PLANNING COMMISISON
SITE PLAN - WAIVER ONLY

CASE NUMBER: SP-2015-0294C PLANNING COMMISSION
HEARING DATE: September 22, 2015

PROJECT NAME: San Marcos Hotel

Re: Request for Compatibility Waiver
LDC Sec. 25-2-1067(C)
LDC Sec. 25-2-1067(G)
"San Marcos Hotel" site plan (SP-2014-0117C)
924 E. 7th St.

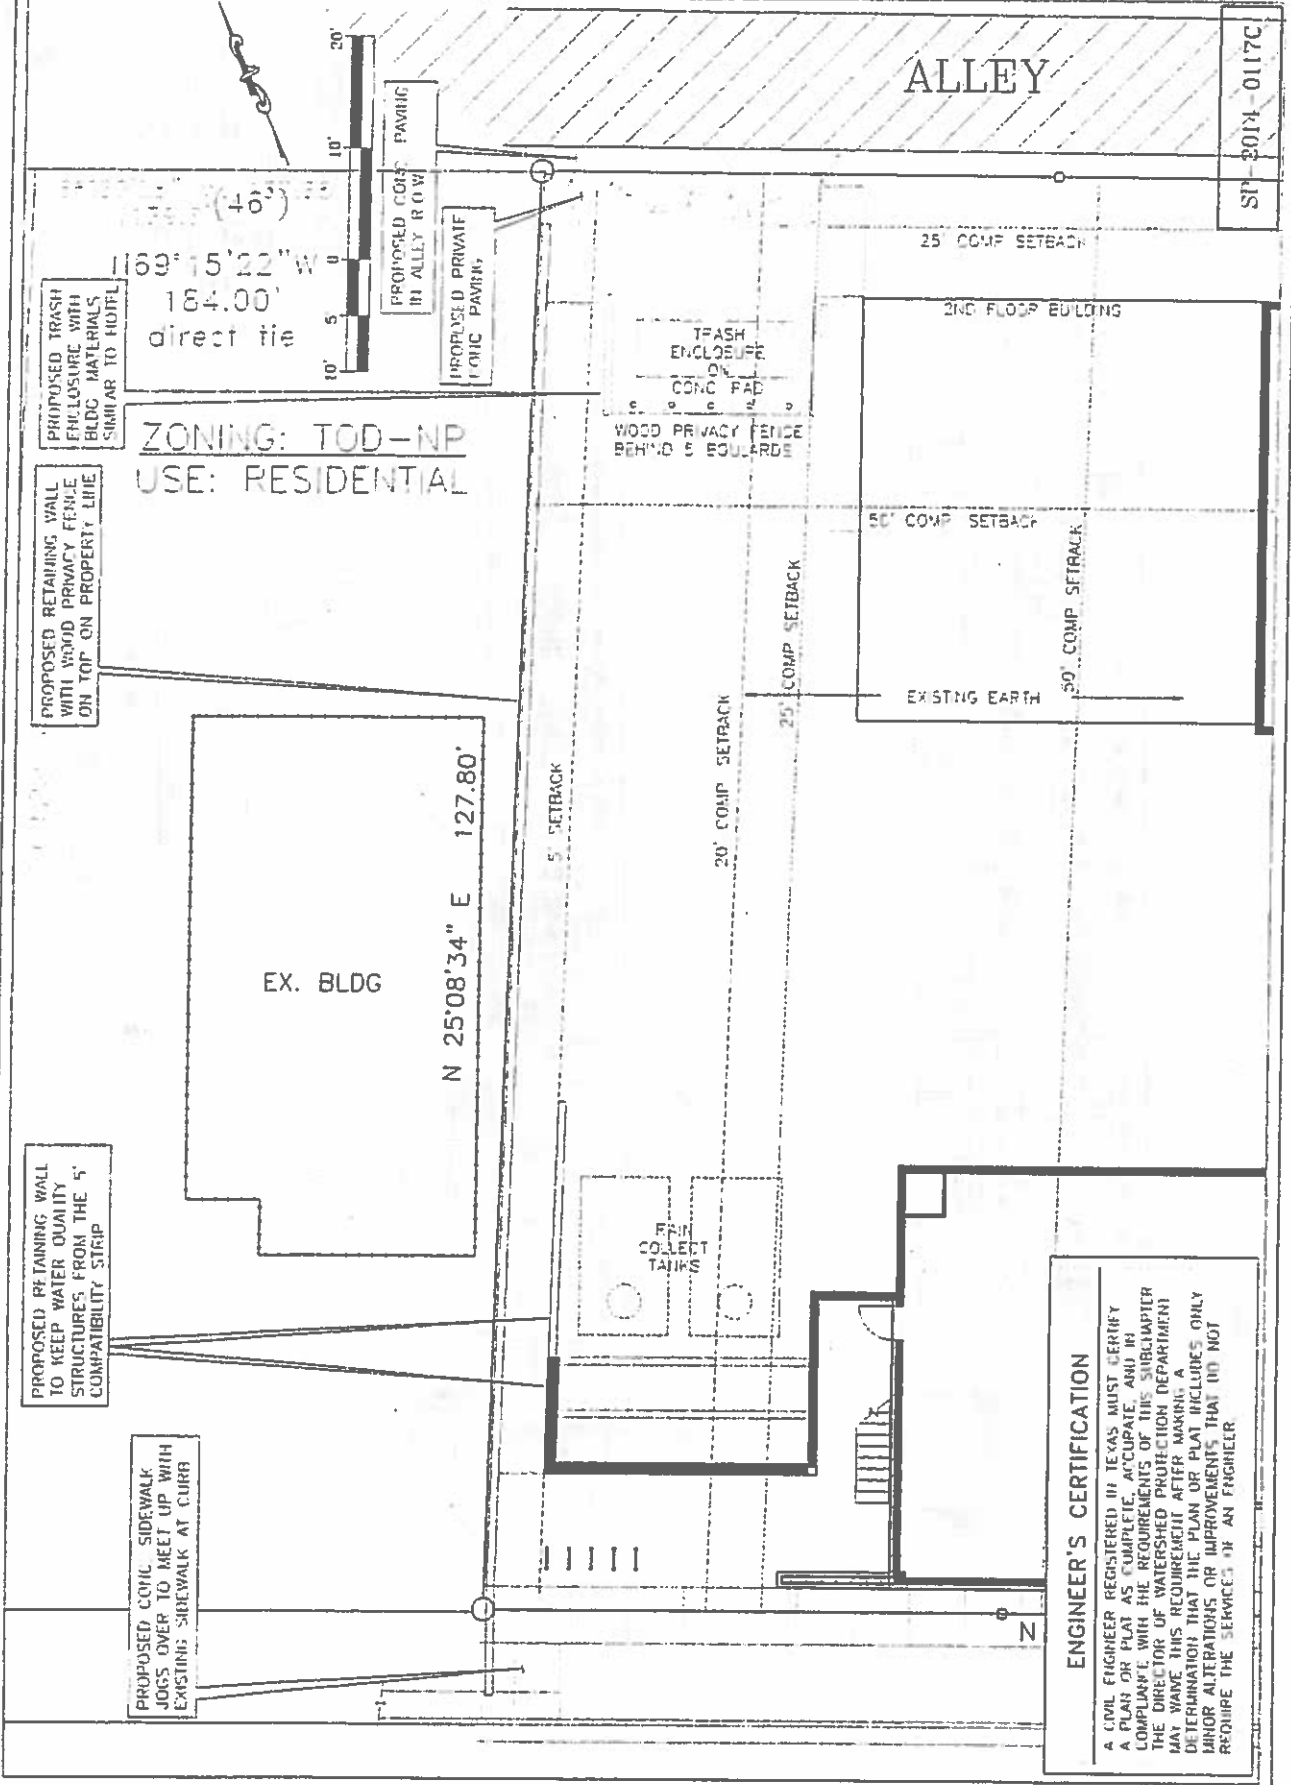
Compatibility standards require a dumpster to be setback from property used or zoned as single family 20 feet. [LDC Section 25-2-1067(C)] The dumpster enclosure will be located 7.5 feet from the west property line. The enclosure will be 6 feet in height, which is an additional screening to the single family property.

All driveways and parking must be setback 25 feet from property used or zoned as SF-5 or more restrictive. [LDC Section 25-2-1067(G)] A portion of the rear driveway, parking and loading zone are within the compatibility setback to the north, encroaching into the setback 7 feet. This is a unique situation, as there's a 20 foot alley between the development and the triggering SF-3-H property. The SF-3 property is the historic French Legation; however the actual French Legation building is approximately 100 feet from the property line.

LDC Sec. 25-2-1067 (C) refers to the location of a trash enclosure within a 20' compatibility setback. As shown on the civil exhibit, the trash enclosure is located within the 20' setback from the western property line. Due to the requirement to keep the street frontages pedestrian friendly, the nature of the topography, building massing, drainage, and similar factors, the northwest corner of the site is the most appropriate place for the trash enclosure. The enclosure is 20' wide and 6' tall; 14' of the enclosure is located within the 20' setback area. Note that the proposed enclosure falls outside the compatibility setback from the north, only from the west setback.

LDC Sec. 25-2-1067 (G) refers to installing a parking area or driveway within a 25' compatibility setback. As shown on the civil exhibit, there is a unique condition along the north of the property adjacent to the alley. The (public) alley as currently constructed is entirely within the compatibility setback area. We are proposing to provide covered parking along the northeast corner of the tract; about 6' of the pavement connecting the parking with the alley falls slightly within the 25' compatibility setback. Further west along the alley we are proposing the loading zone; about 7' of this is within the 25' compatibility setback. West from there is the trash enclosure; the drive aisle to access the enclosure falls within the 25' compatibility setbacks from both the west and the north sides. Our justification for allowing these pavement improvements within the north 25' compatibility setback includes:

Due to the constraints and requirements of the site, staff recommends approval of both waivers.
